**Area Walk-By Checklist (AWC)**

Location: Bldg. CB Floor El. 240'-0" Room, Area<sup>13</sup> R230

Location: Bldg. Aux Floor El. 220' Room, Area<sup>13'</sup> R118

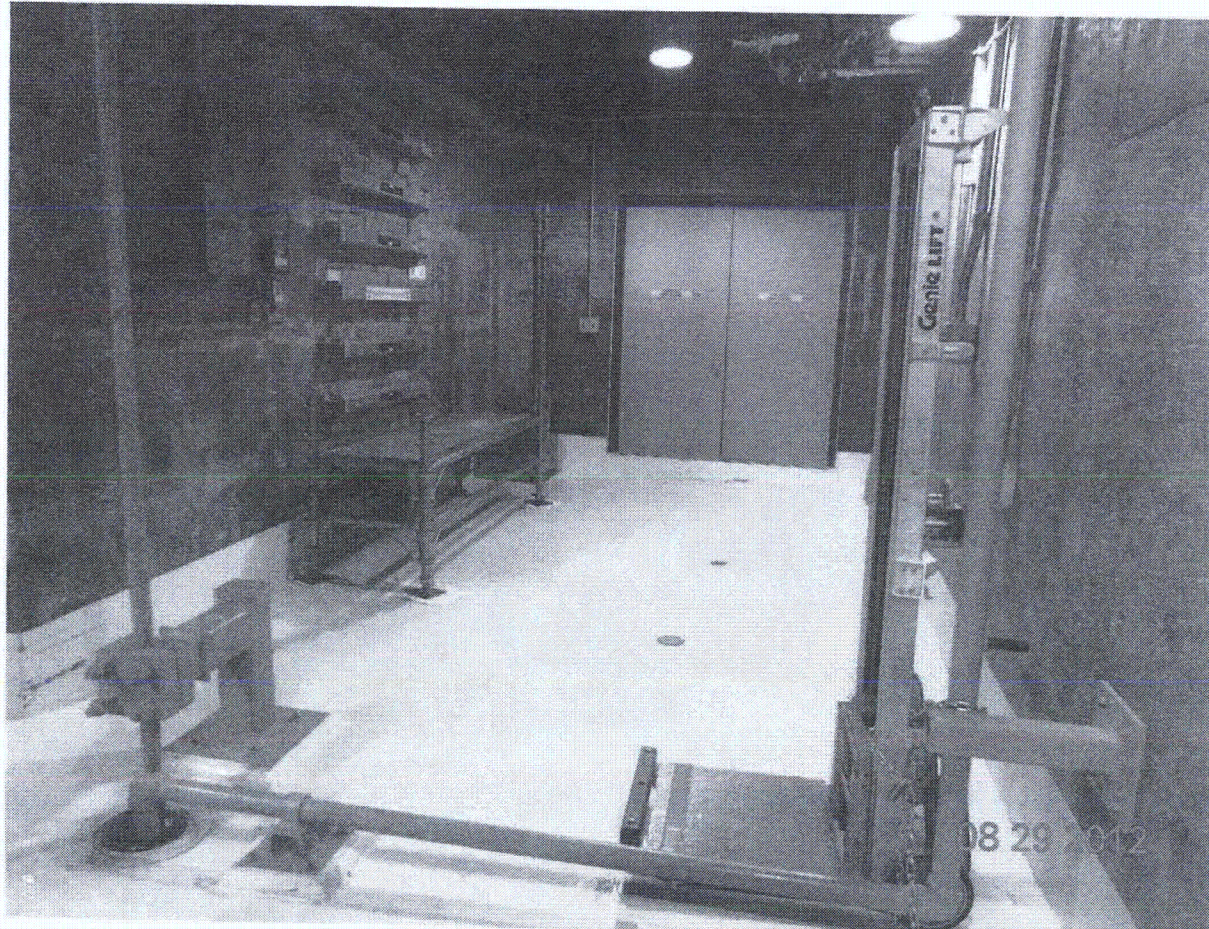
*Genie Lift & temporary scaffold are proper tie down and is acceptable by SWEs.*

*Block walls are properly restrained and is acceptable.*

Location: Bldg. CONTROL Floor El. 180' Room, Area<sup>13</sup> RB 48

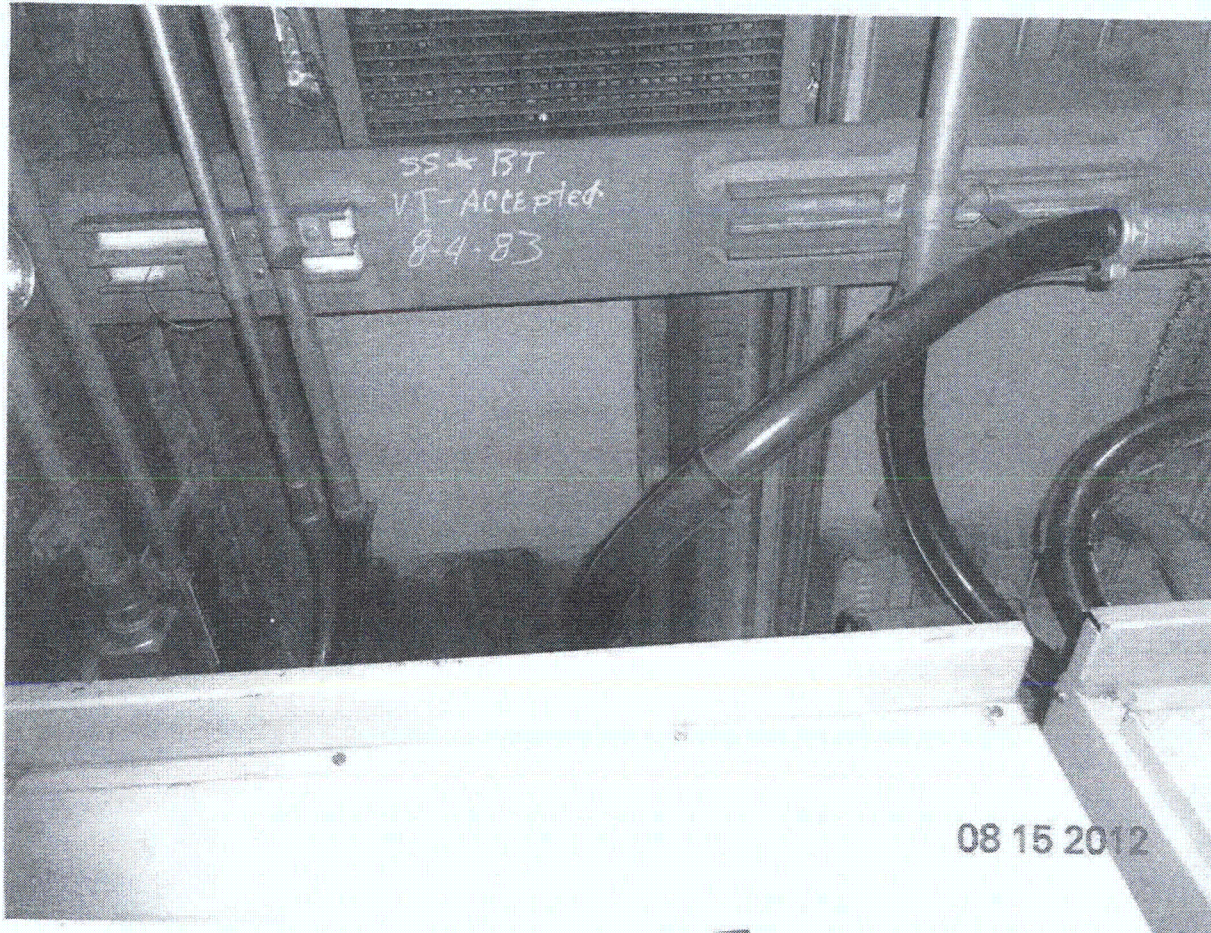
*FOR LIGHT FIXTURE 8/16/12*  
*CLOSURE SCREWS NOT FULLY ENGAGED, ADJACENT TO 1DD1 125 VDC SWITCHGEAR (SEE SHEET FOR PICTURE) DV 8/16/12*  
*REFER TO CR 505954.*

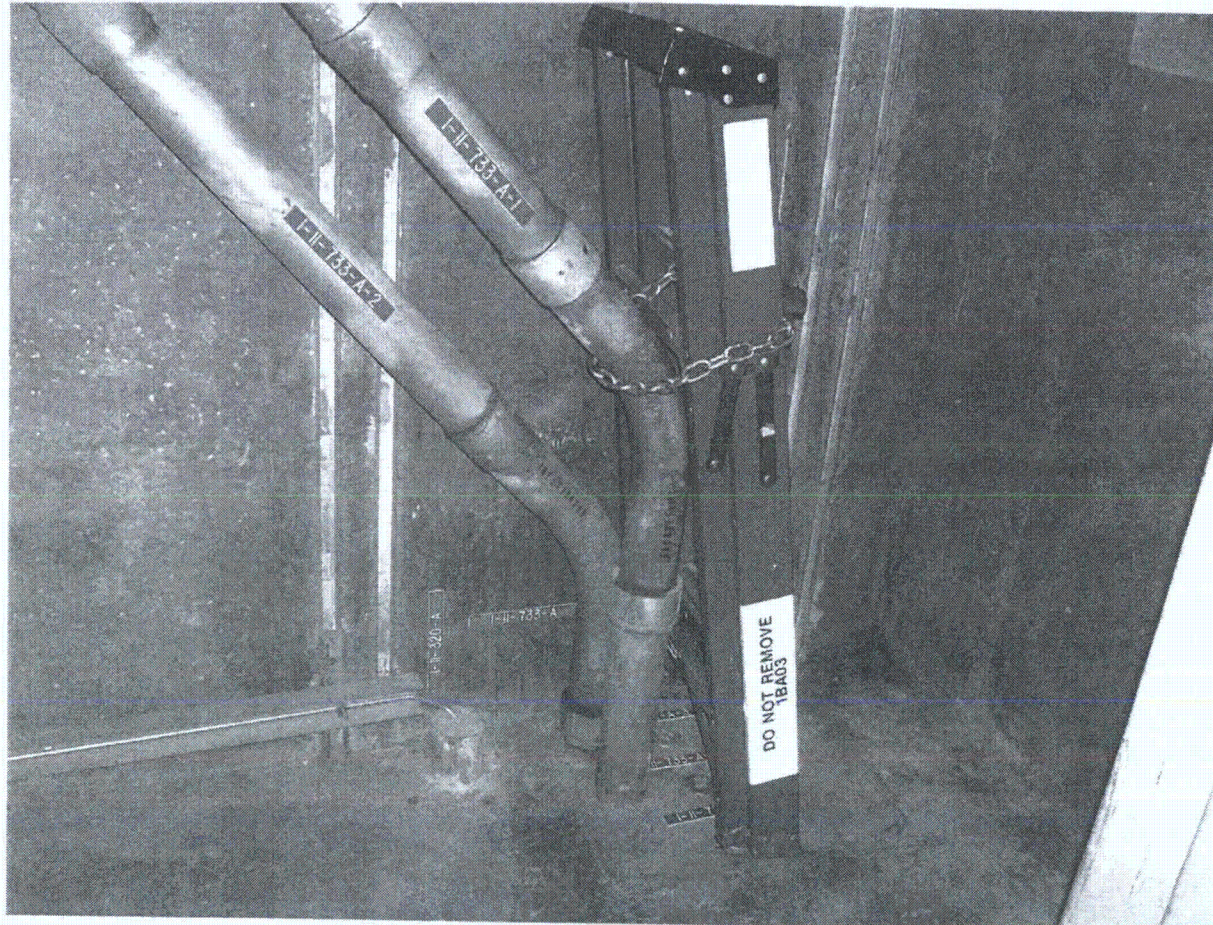
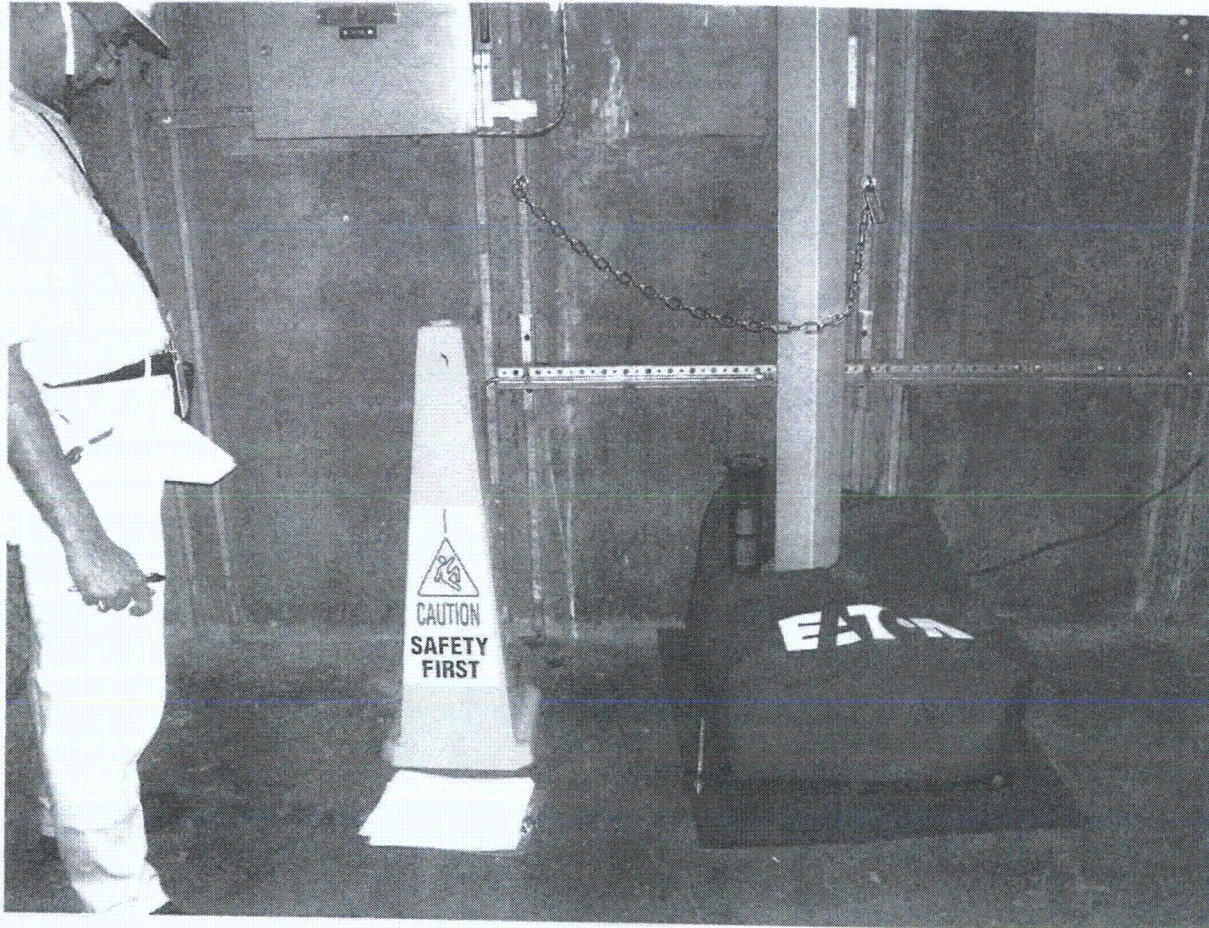
*Span*  
Fence is track welded to the frame structure. Fence is 30" south of panel, 8" from East end of panel. Due to the light weight of fence, the deflection of fence is judge to be adequate during seismic condition. See Drawing AX111A03-1 Rev. 9, CB Floor Plan Elev. 200'-0" Level A.

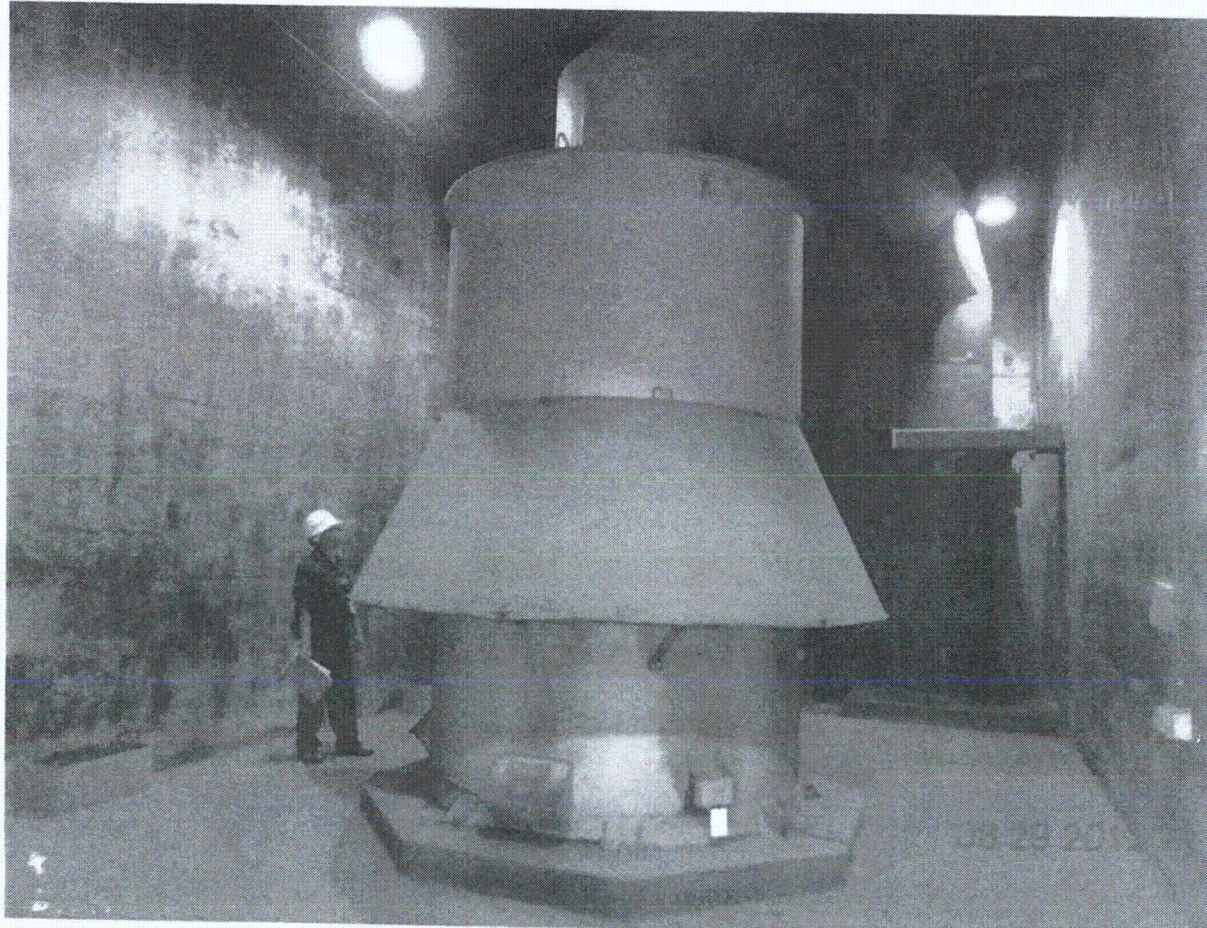
HVAC ACCESS PANEL NEAR THE FLOOR IS MISSING TWO LATCHES. THIS CONDITION IS NOT A SEISMIC CONCERN BASED ON THE LOCATION OF THE PANEL AND THE TWO REMAINING LATCHES. REF. CR # 540141

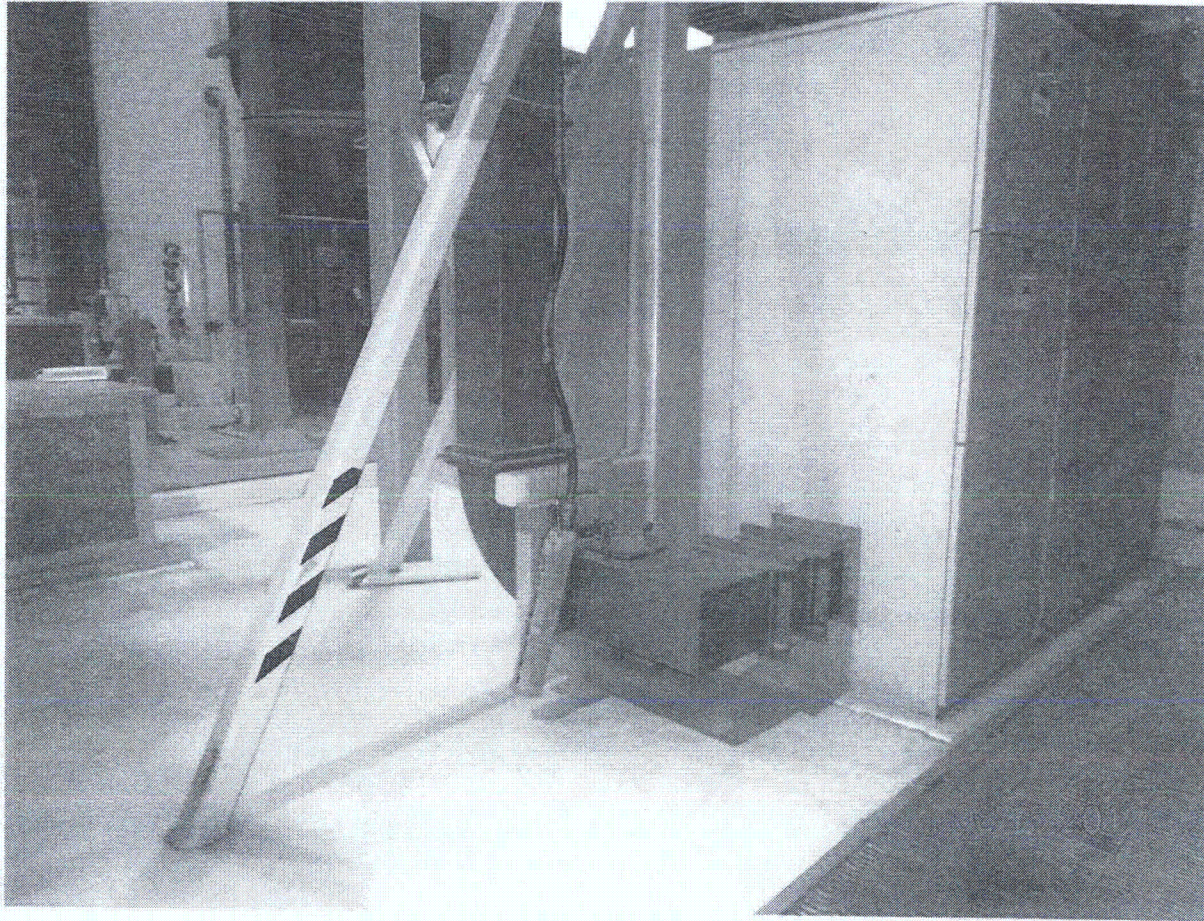
*Floor grating near Engine Control Panel Diesel Generator 1B (1-2403-PS-064) is not bolted down. The grating is also slightly bent. This is not a seismic/structural concern based on the configuration (shape) and location of the cover. - CR 502522.*
